HARTZELL PROPELLER INC.

SERVICE BULLETIN

Blade Angle Adjustment

Figure 1
Low Pitch Stop Location

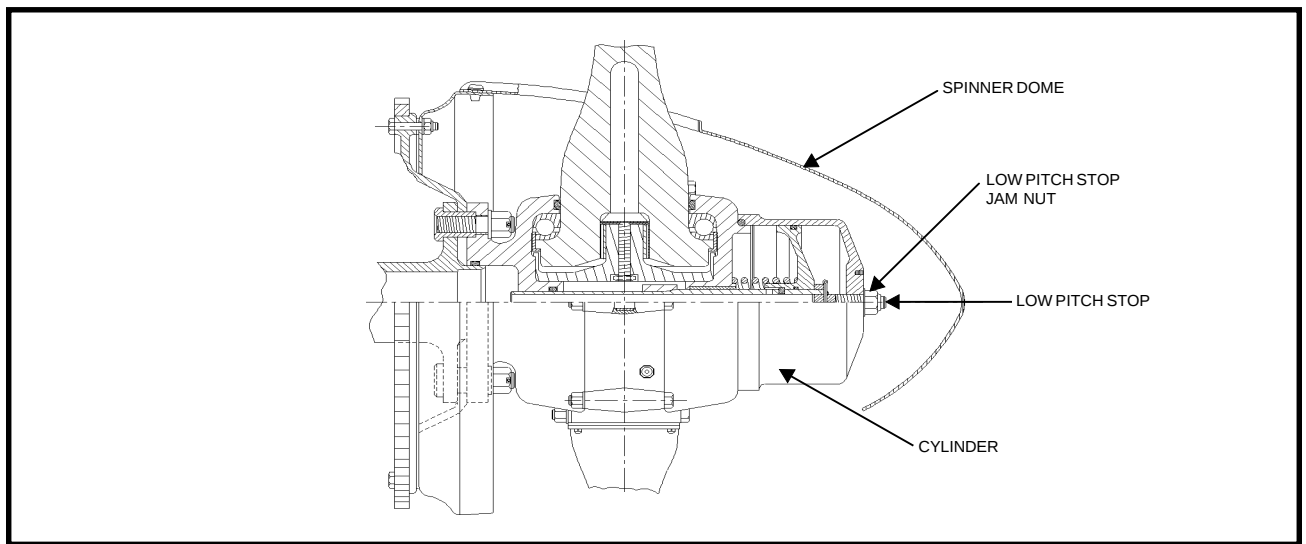
- (1) Remove spinner dome.
- (2) Loosen low pitch stop jam nut (see Figure 1)
- (3) Turn the low pitch stop screw in 2-1/3 turns. This will increase the low pitch angle from 10.5° to 13.8°.
- (4) Tighten jam nut and torque to 15 ft/lbs (+/-10%).
